CLARIFICATION STATEMENT

PROPOSED HOUSE EXTENSION

4 Albany Close, Ickenham, Uxbridge
UB10 8QW

Re: Acknowledging receipt of planning application for 4 ALBANY CLOSE-79843/APP/2025/3245

3 Rear Elevation (South)

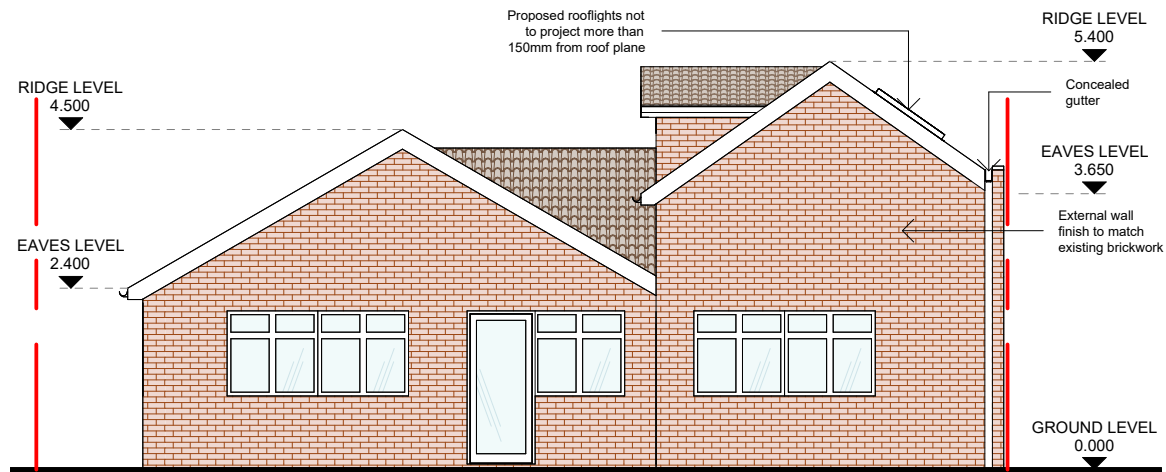
In response to the expressed concerns, we have adopted a proactive strategy by eliminating the rear-facing bedroom window from the revised design. Updated architectural drawings that reflect this modification will be submitted accordingly. This alteration ensures that there will be no potential for overlooking the adjacent property.

In light of the above amendments and clarifications, we respectfully request that the application be reconsidered. We trust that the removal of the rear window fully addresses the concern relating to the neighbouring amenity.
